# Addendum #1

Attn: Estimator	Date: February 21, 2024
From: Lisa Donahue, Project Administrator	Pages: 92 (including cover page)
Re: Bay City Public Schools	Project: 2024 SF BP 11 – Eastern HS at Handy MS
CC:	Proj. #: A23904

PROJECT TITLE  
 RENOVATION FOR BCPS:  
**BAY CITY EASTERN HIGH SCHOOL AT HANDY M.S.**

PROJECT NUMBER <b>2018040.16</b>	SHEET NUMBER <b>A2.11</b>
PROJECT DATE FEBRUARY 1, 2024	
CHECKED BY J.A.R.

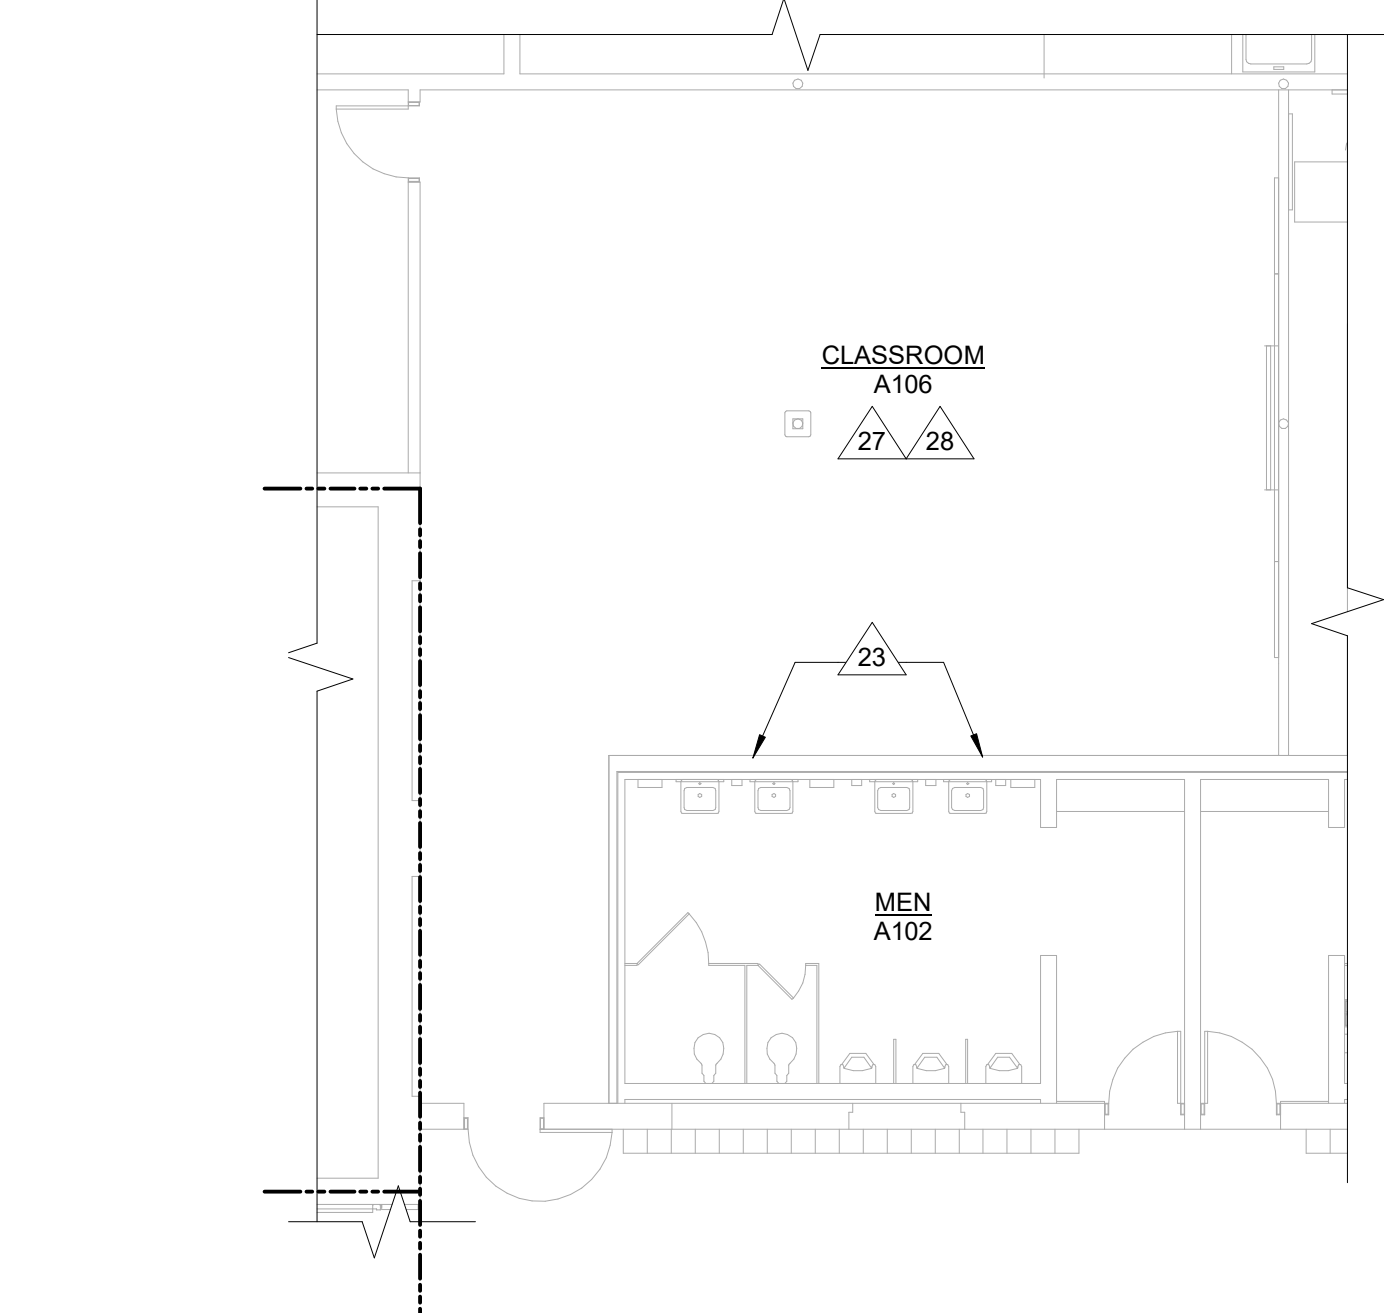
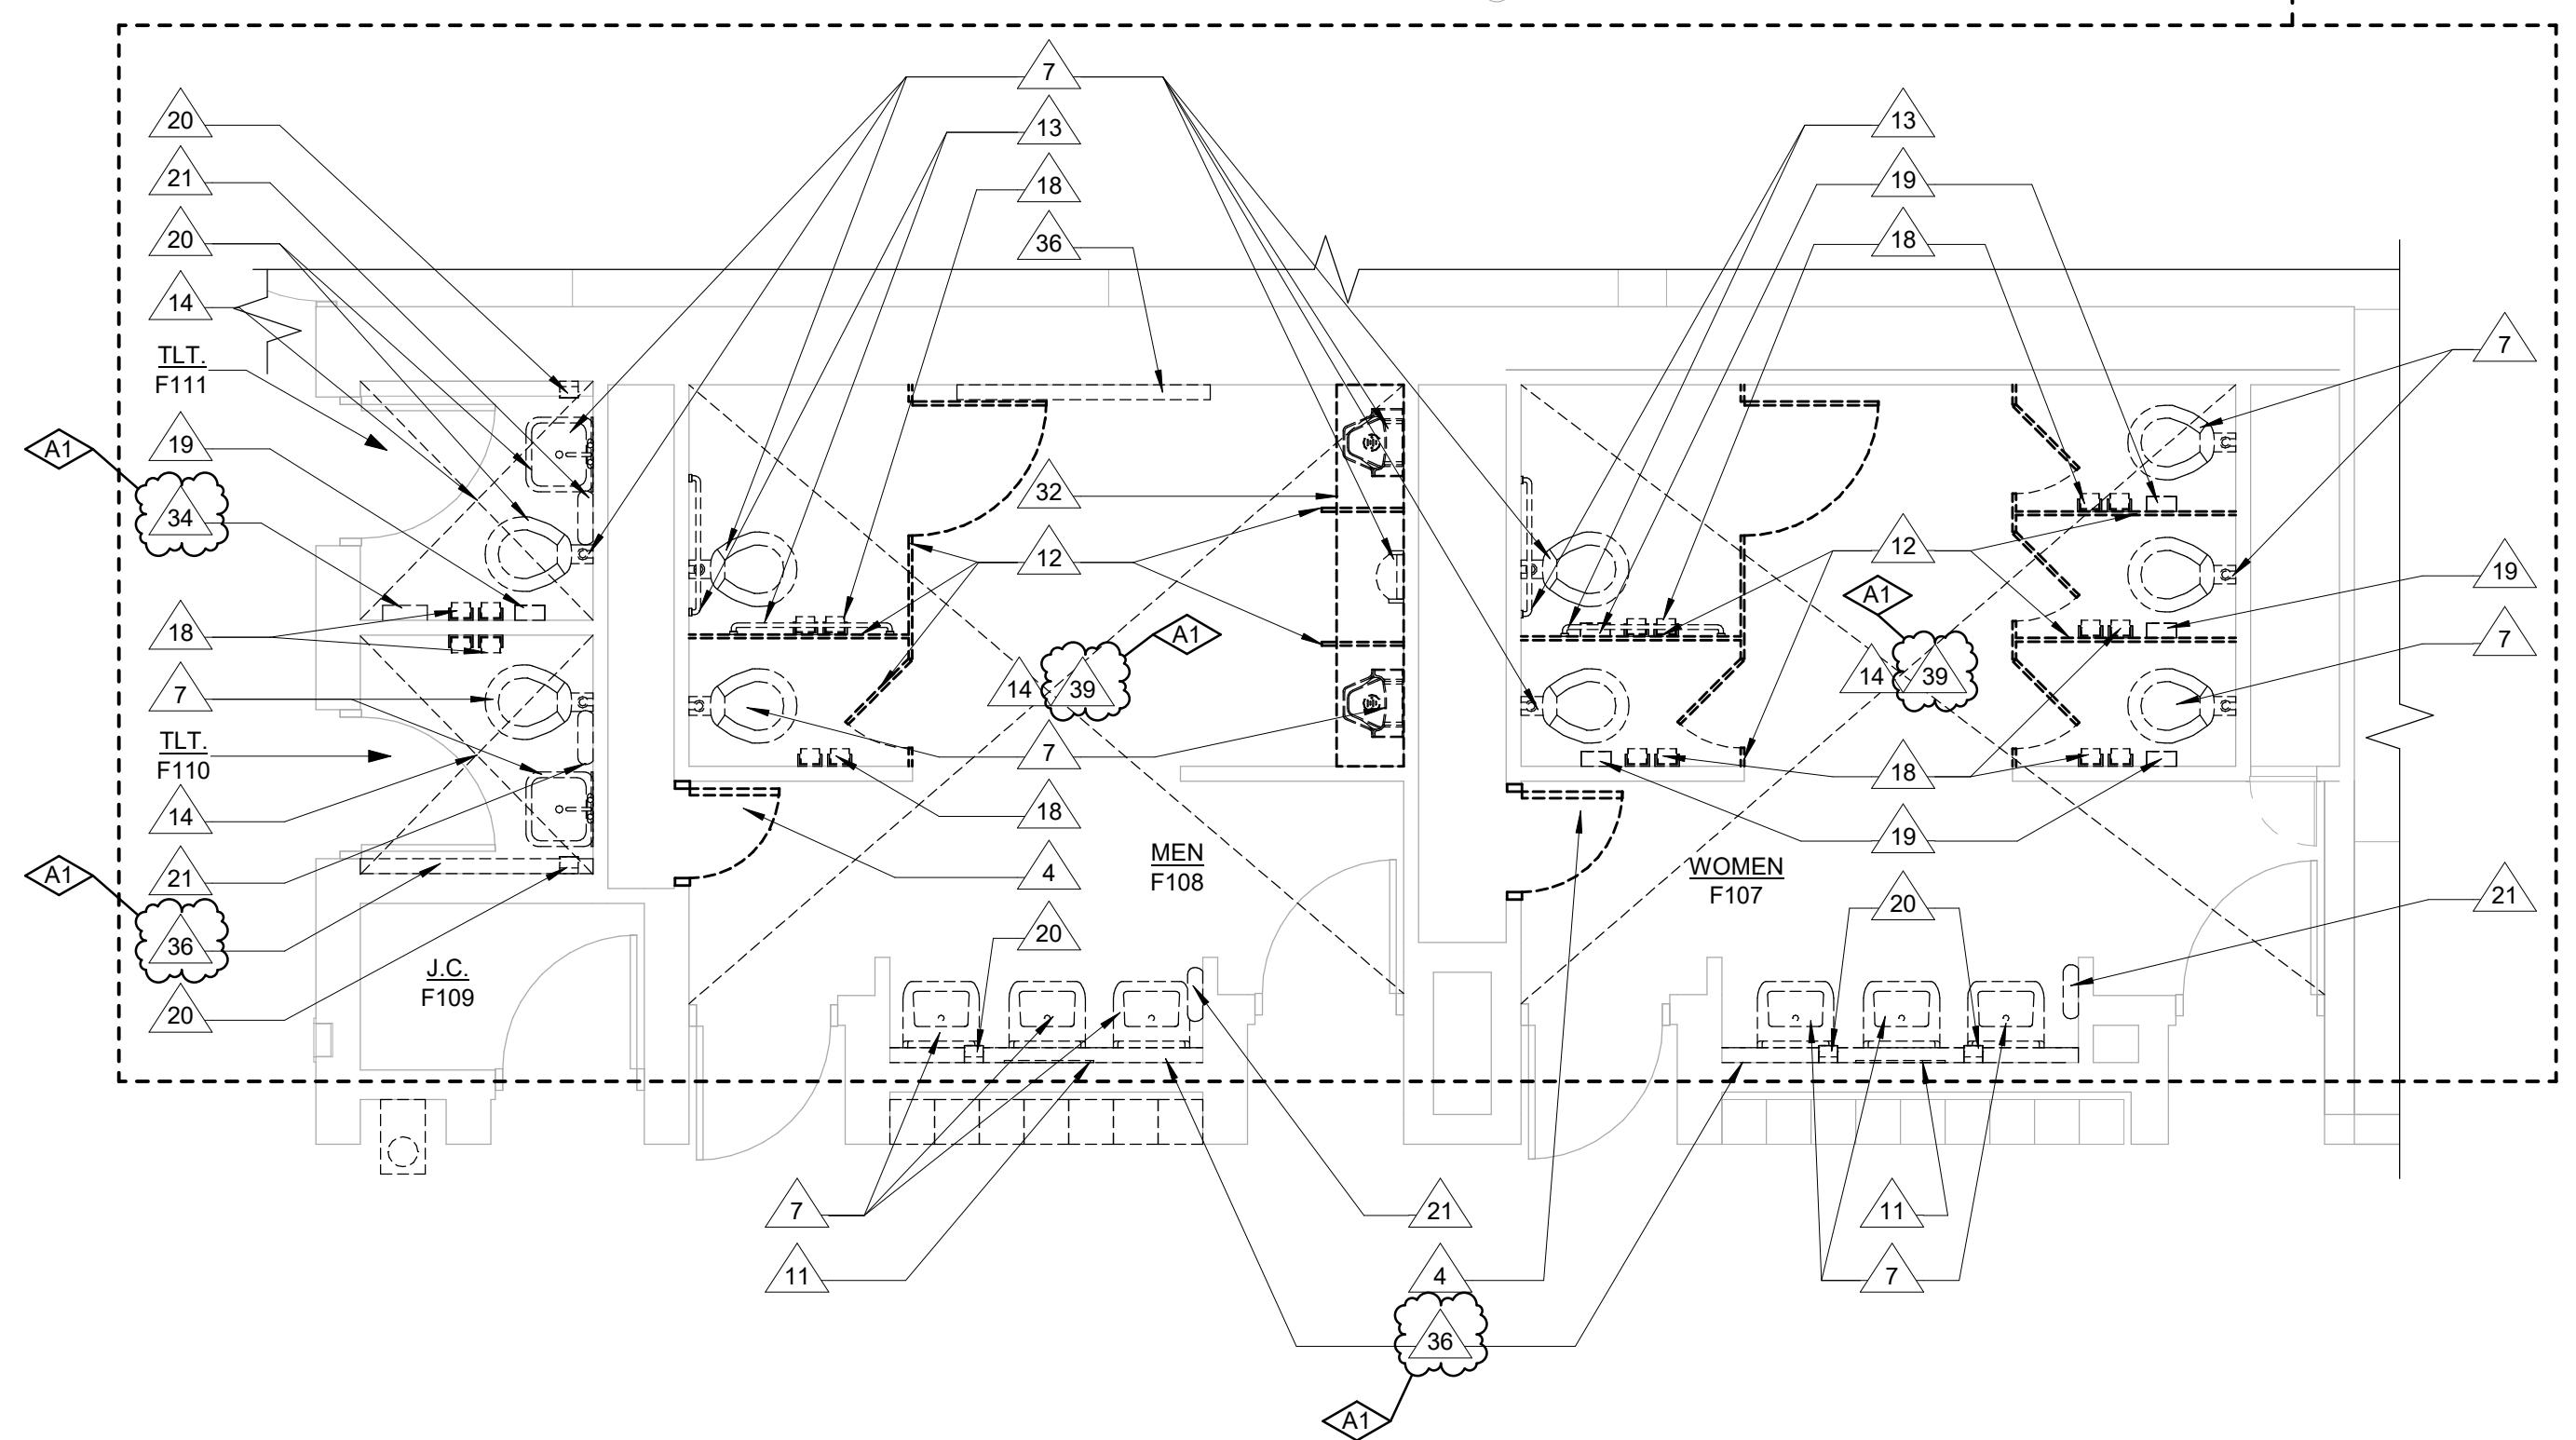
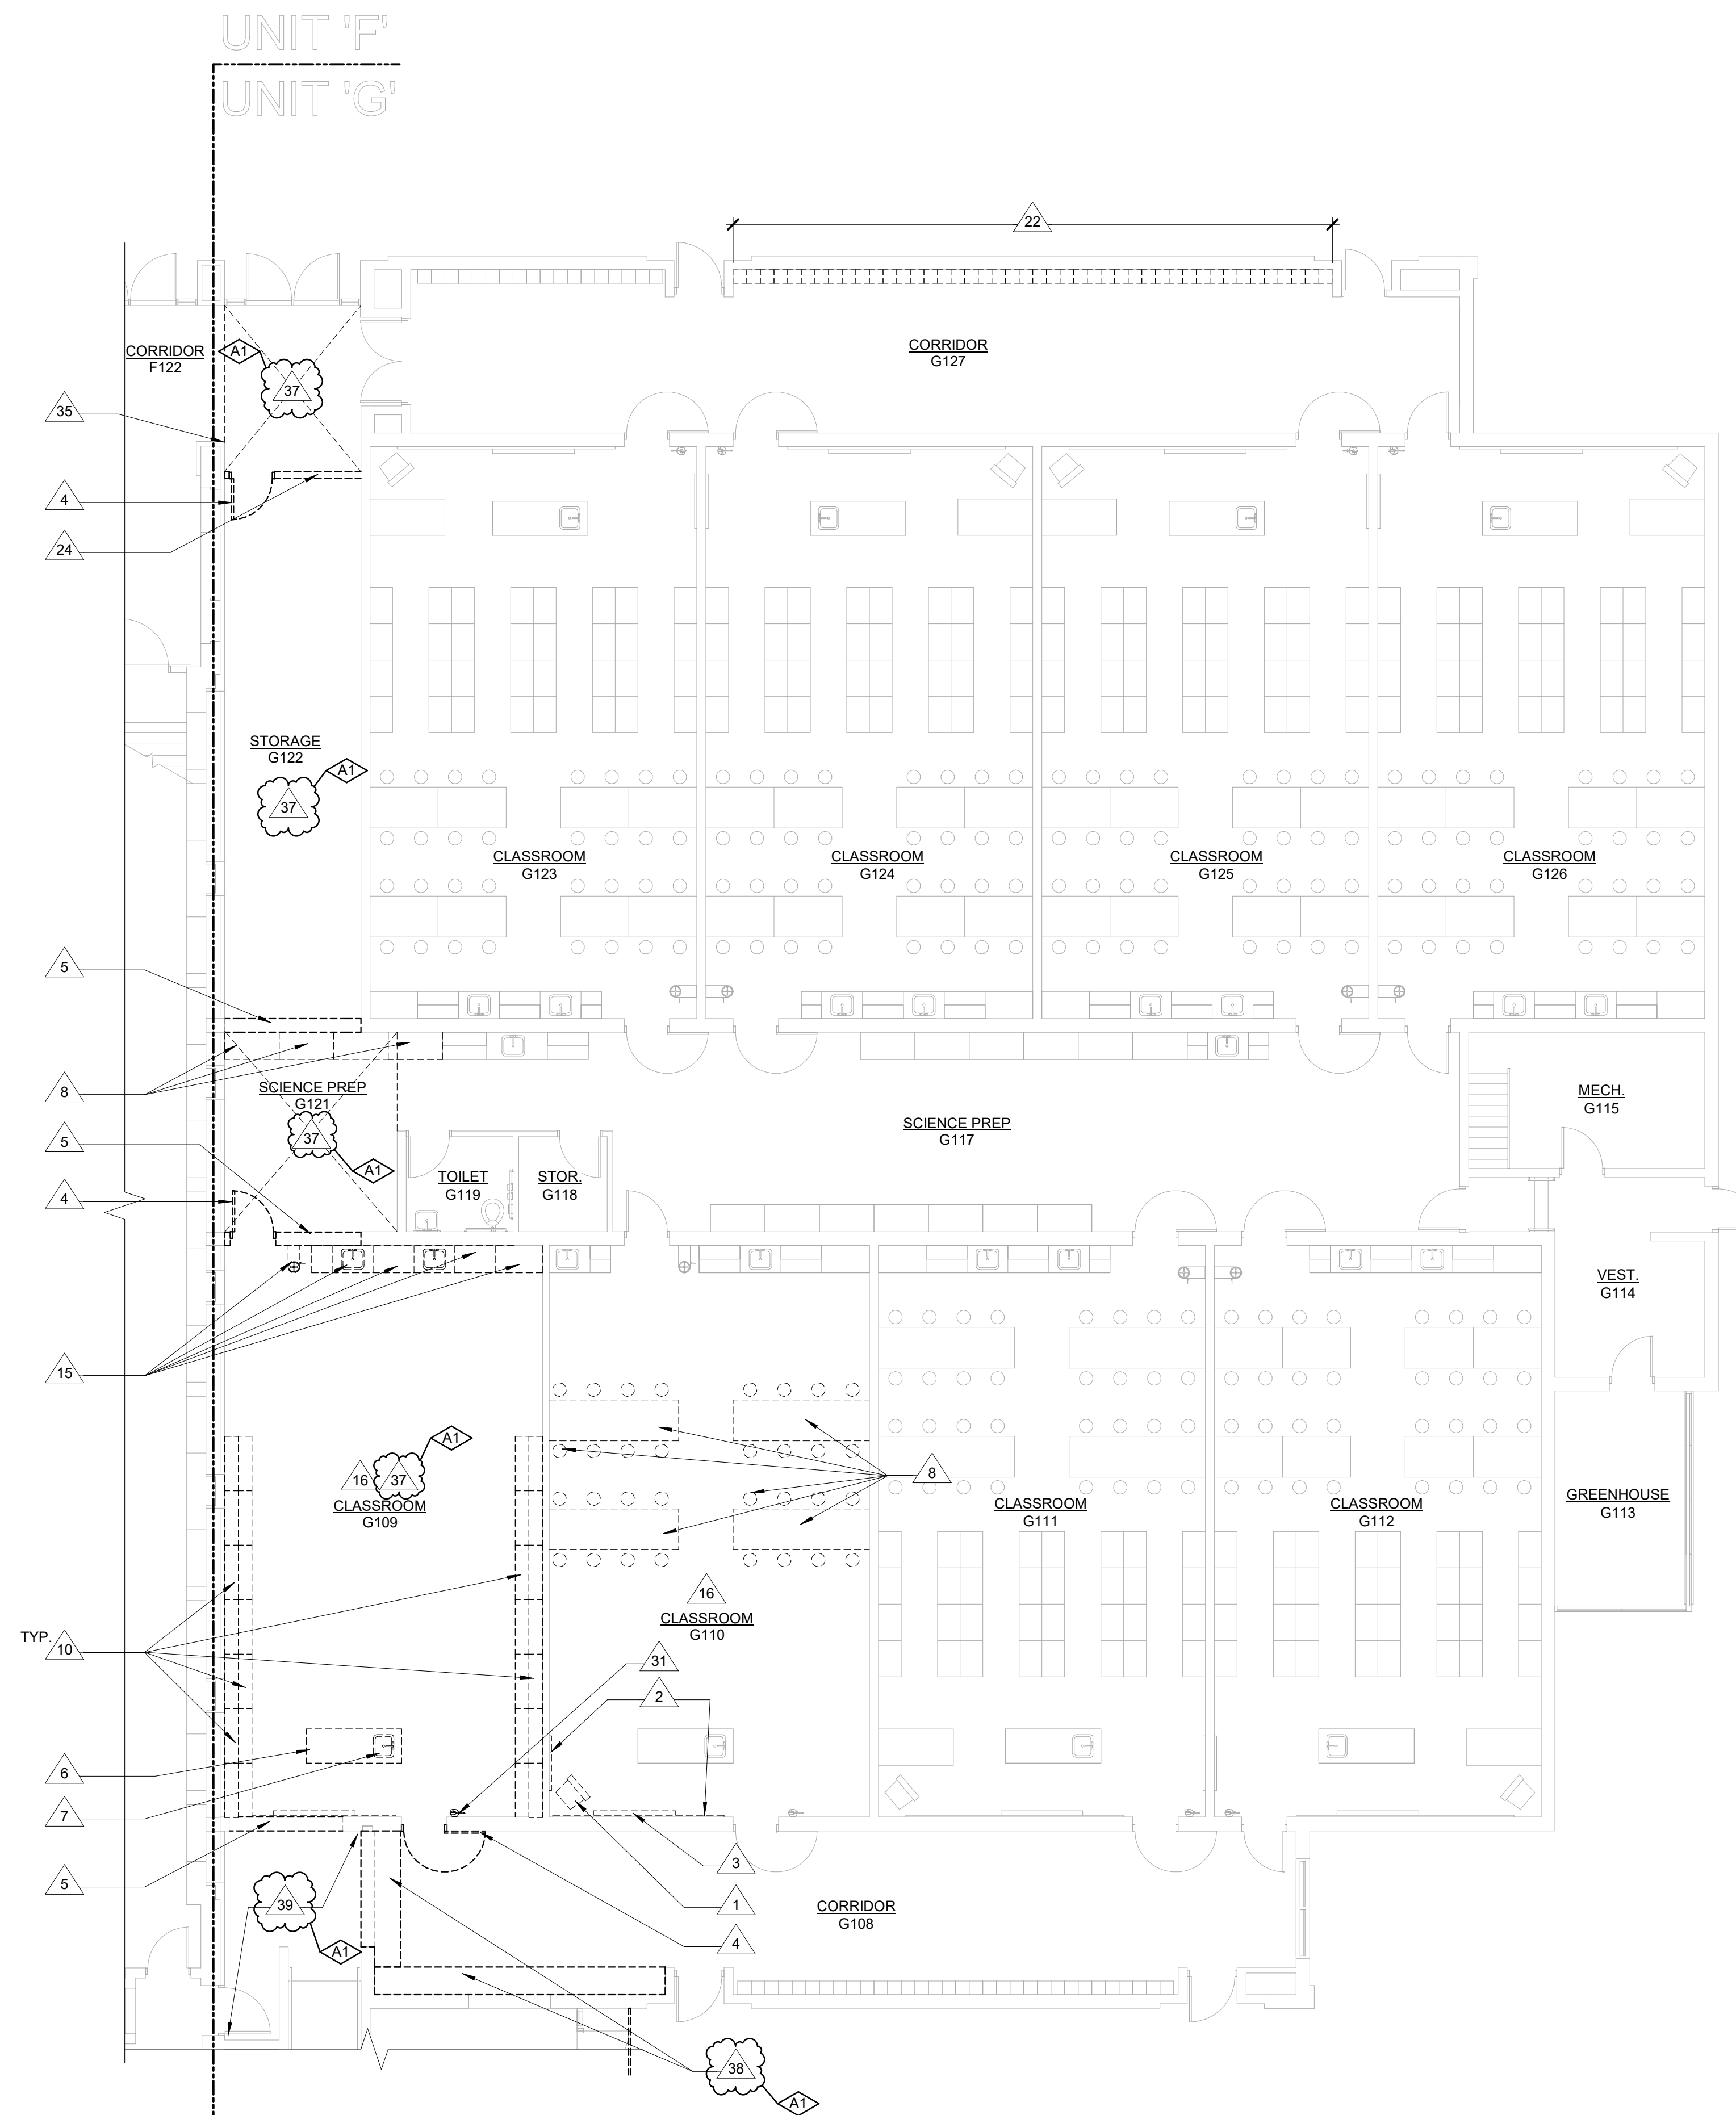
- Item A6: Reference Sheet A2.11 & A2.12 (Re-Issued)
- A. Revised demo keynote #22 to remove lockers per Alternate No. 2 in lieu of to be relocated.
  - B. Revised demo keynote #27 to grind off adhesive.

- C. Revised demo keynote #30 to remove mud bed down to concrete slab or substrate.
  - D. Added demo keynote #36 to remove existing structural glazed tile shelves in the toilet rooms.

- E. Added demo keynote #37 to remove existing VCT flooring and base in existing classrooms (G101, G102, G109), Science

- F. Added demo keynote #38 to sawcut and remove existing terrazzo in Corridor G103 & G108.
- G. Added demo keynote #39 to strip and prep existing terrazzo for new VCT.
